**HOWELL TOWNSHIP PLANNING COMMISSION
REGULAR MEETING**

A. Old Business:
- B. New Business:
 1. Kory Leppek, PC2025-01, Parcel # 4706-20-100-027, 4640 W. Grand River Ave.
 Preliminary Site Plan Review
 2. Renewable Energy Ordinance - Discussion

Site Plan Review For Howell Township, Michigan

Applicant:	Kory Leppek
Project Name:	Leppek Landscapes
Plan Date:	December 16, 2024
Location:	4640 W Grand River
Zoning:	Industrial Flex Zone (IFZ)
Action Requested:	Preliminary Site Plan Approval

ISOMETRIC VIEW 2
NOT TO SCALE

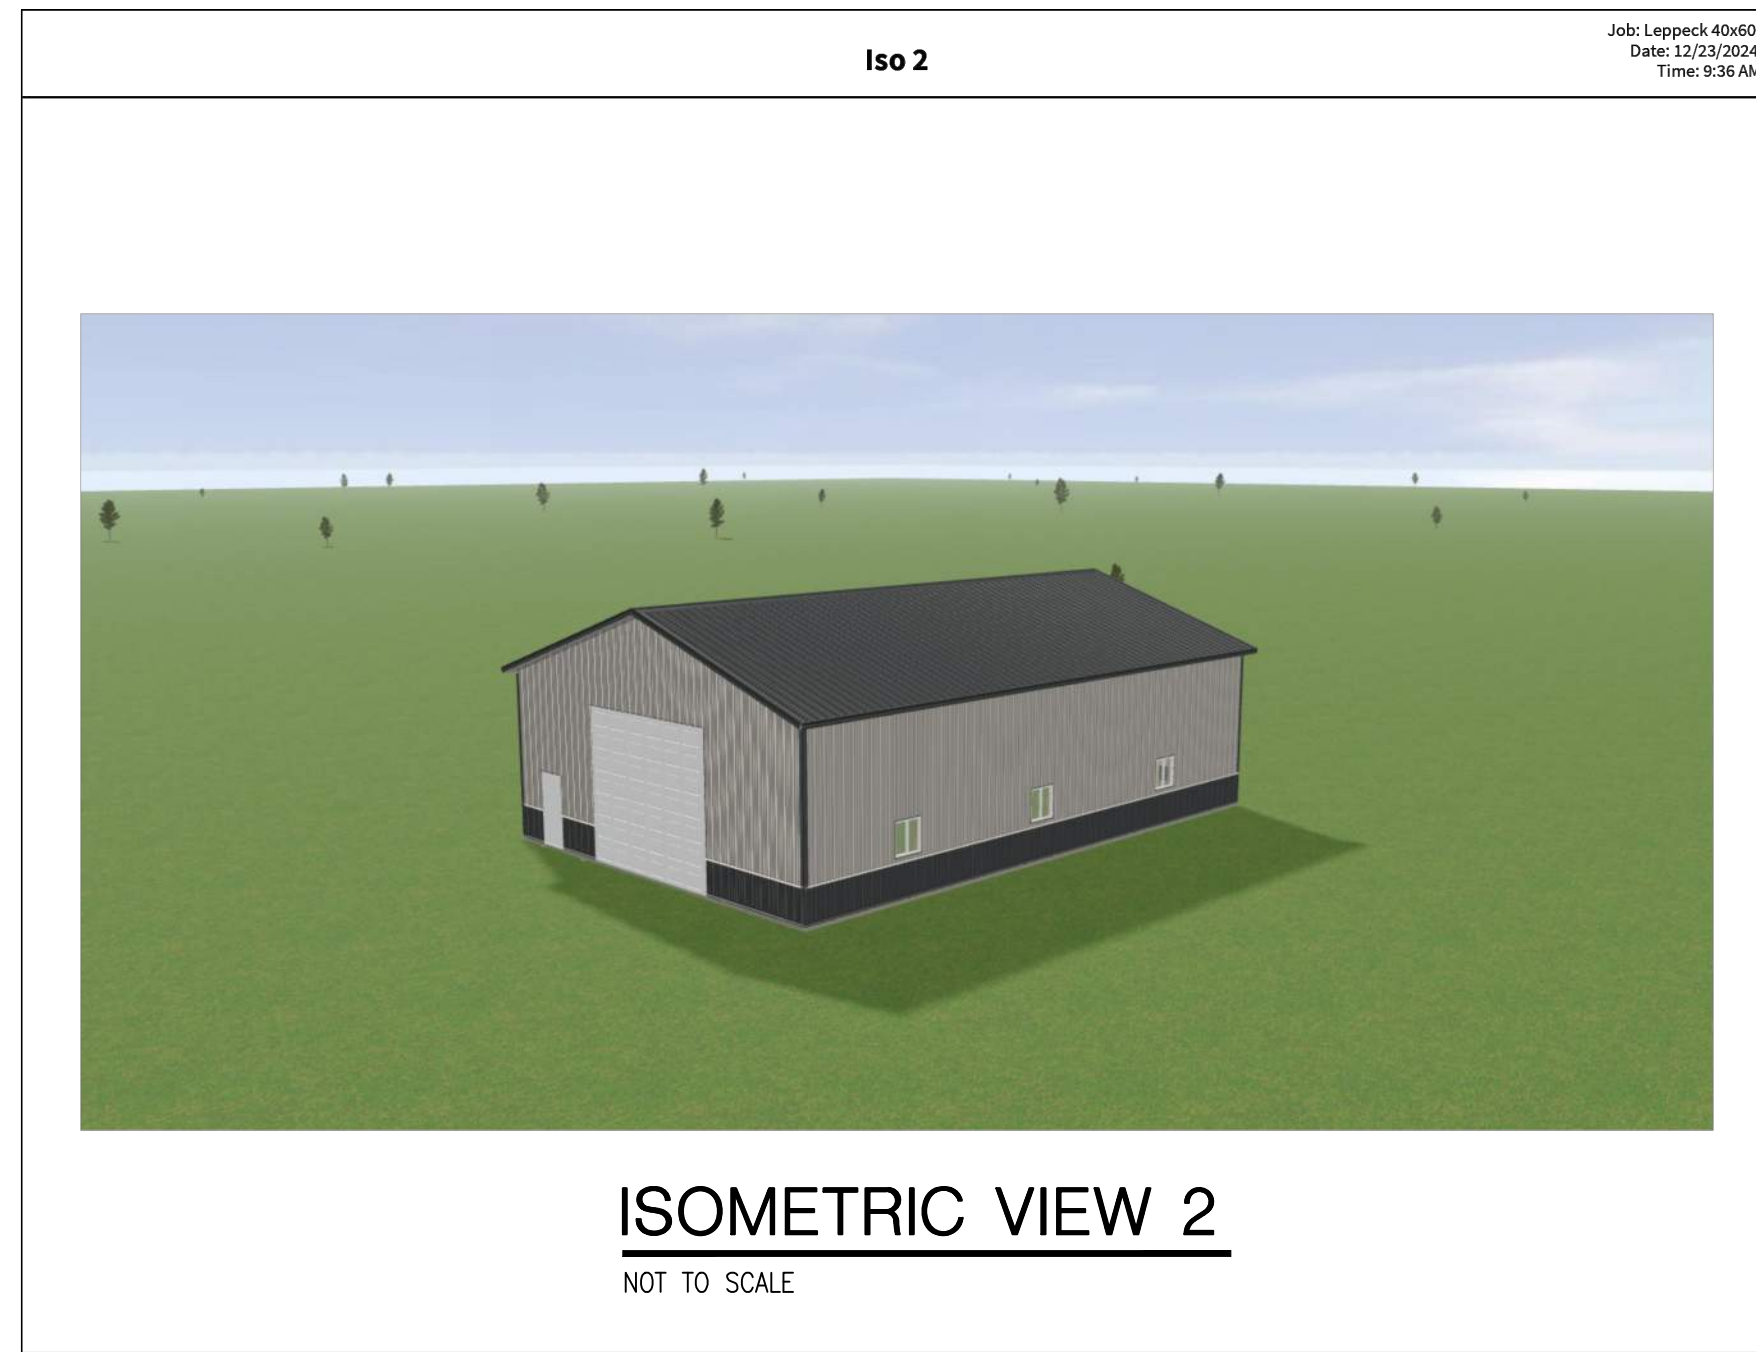
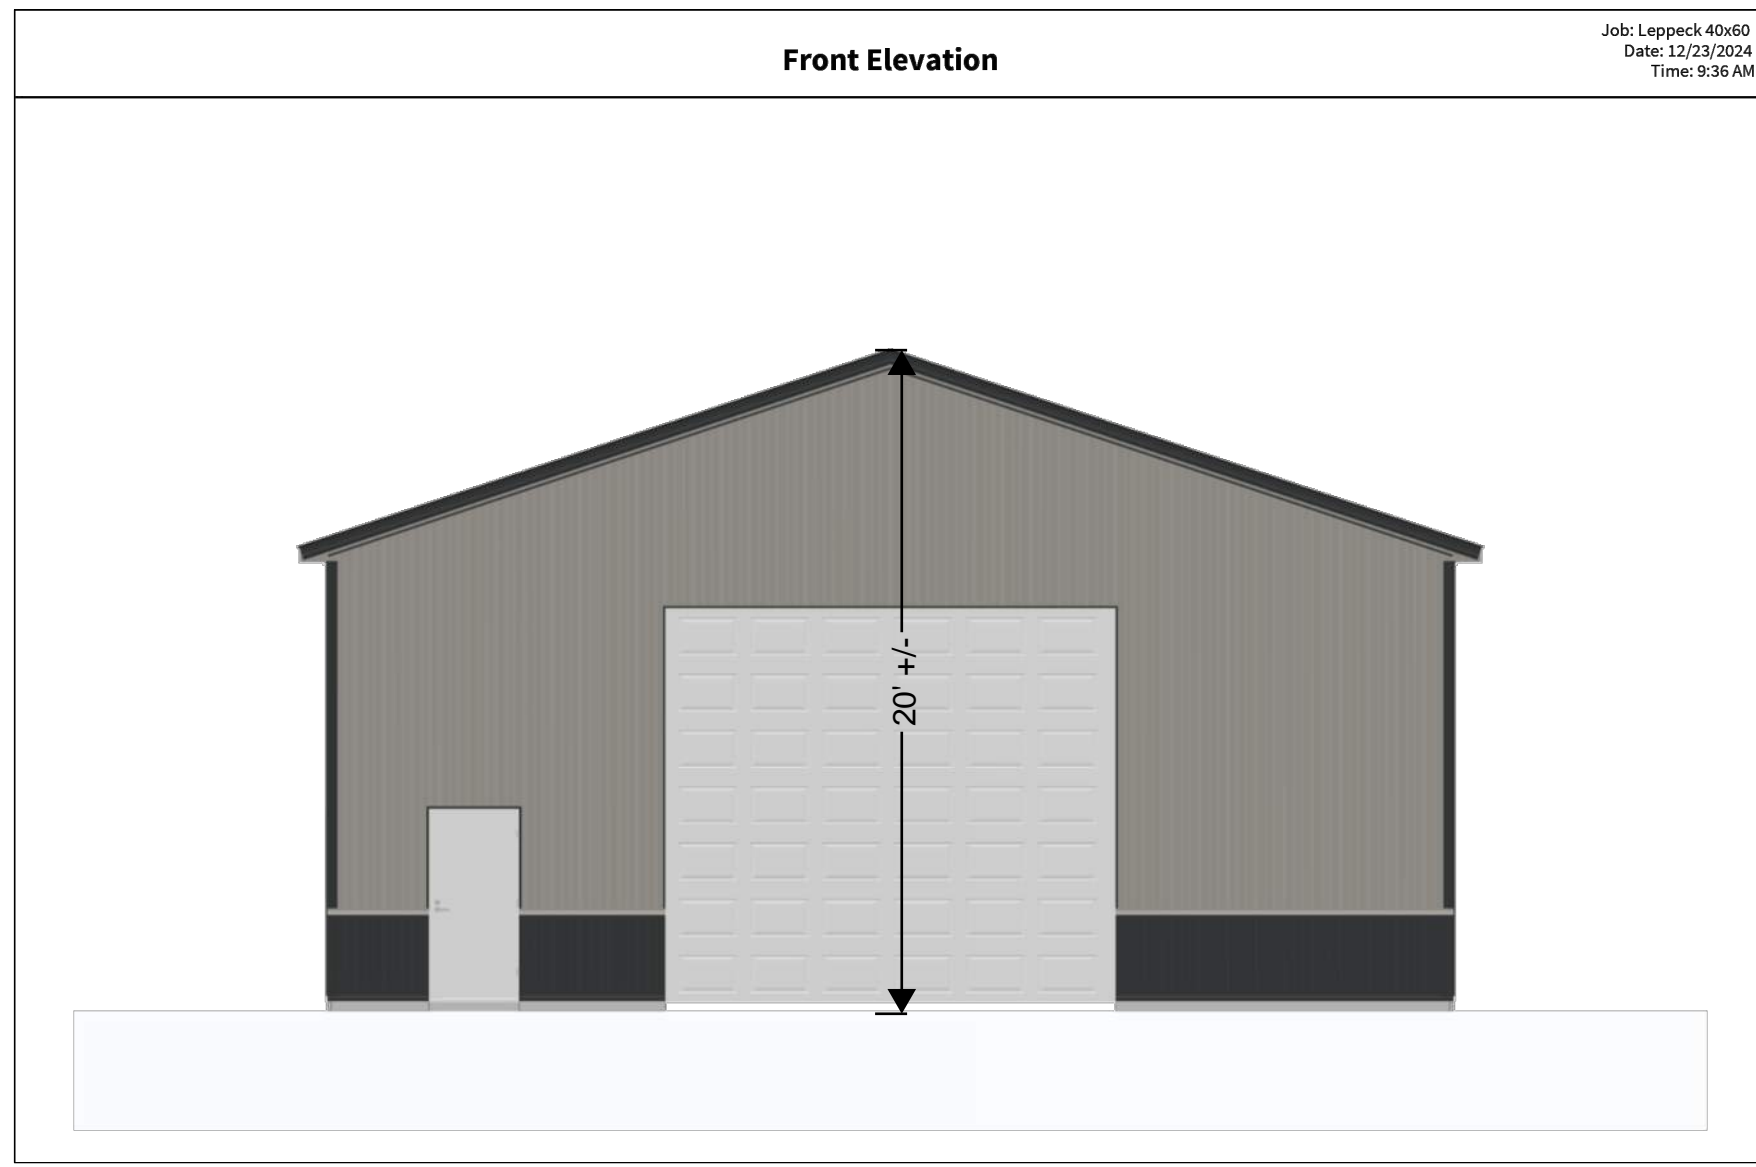
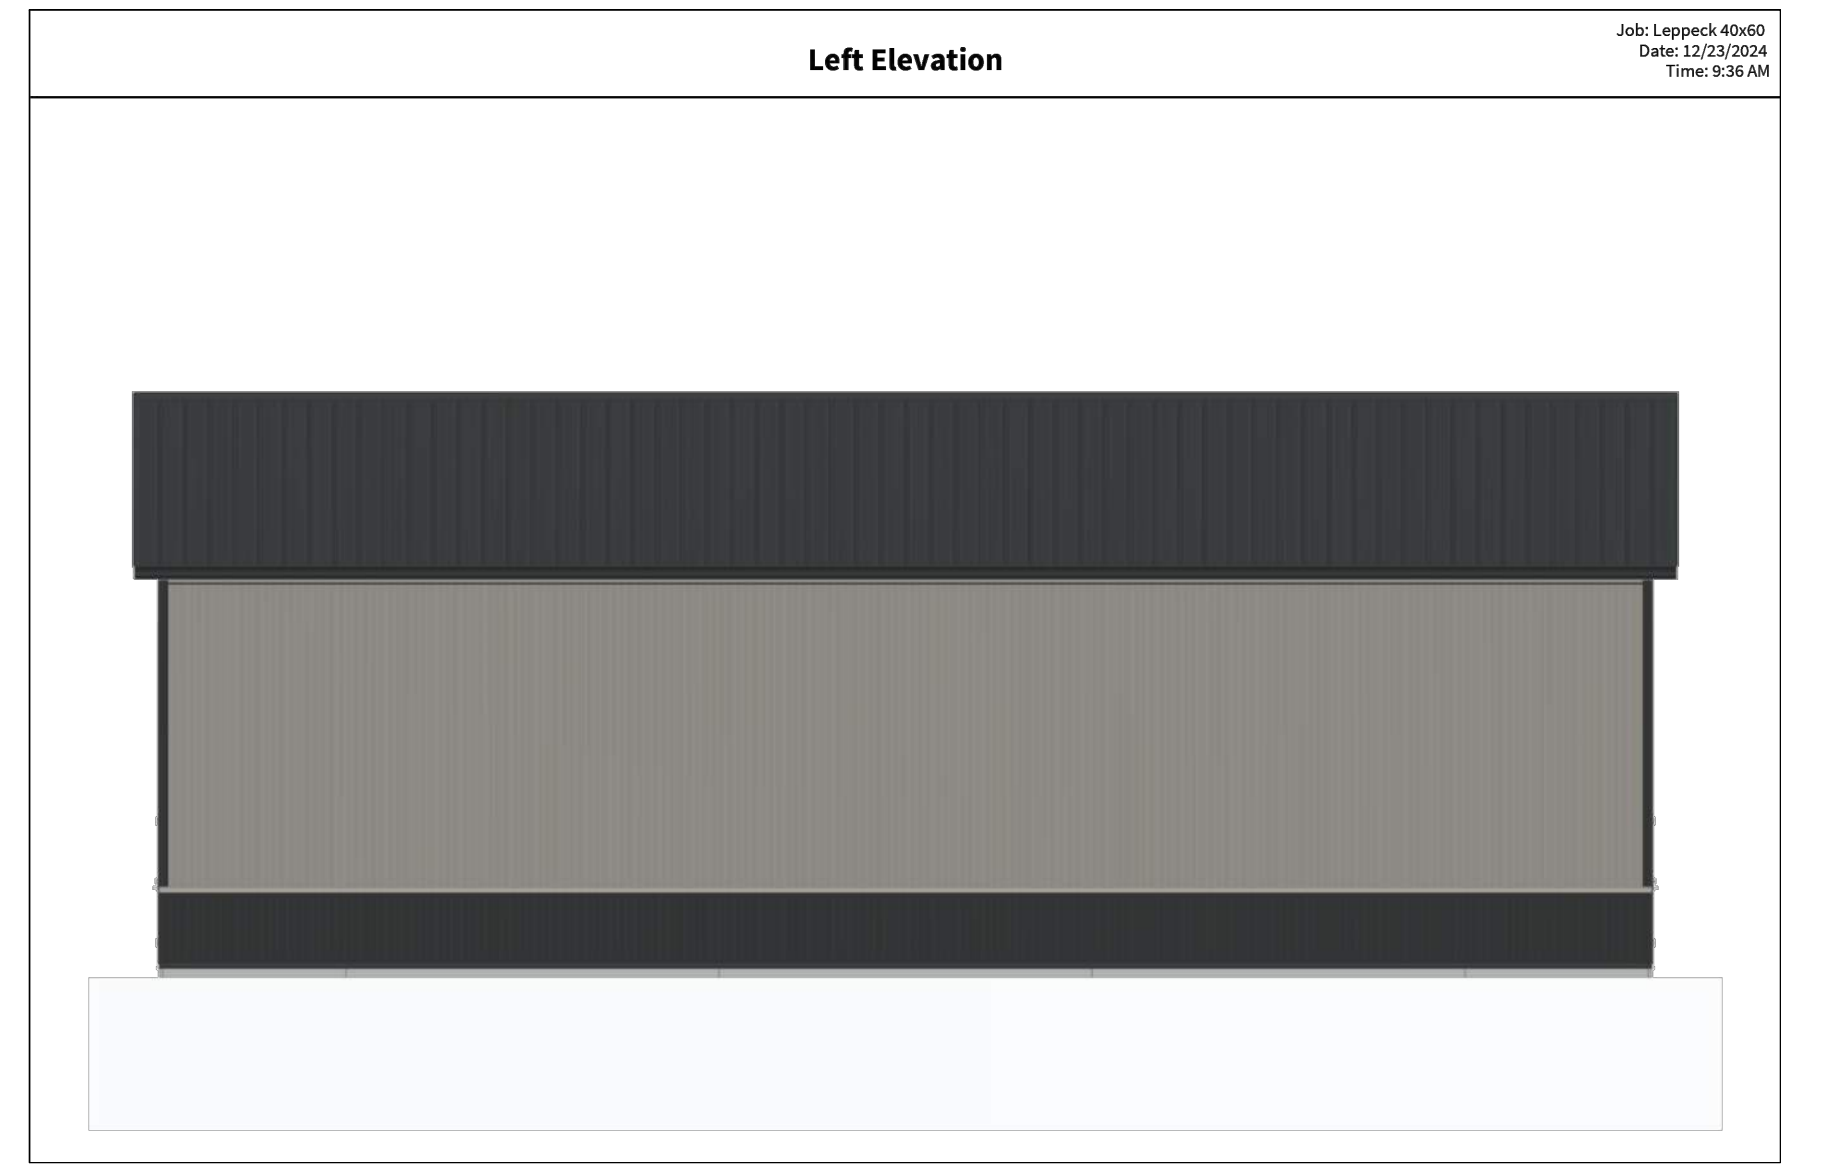
Insufficient floor plans and elevations have been provided on Sheet A-1. Elevations should be to scale and include building materials. A detailed floor plan showing the intended use of the proposed pole building should be included. Detailed floor plans and elevations for the existing building should be provided as well.

Items to be Addressed: *1) Provide scaled elevations for the proposed building. 2) Provide detailed floor plans for the proposed building. 3) Provide scaled elevations for the existing building. 4) Provide detailed floor plans for the existing building.*
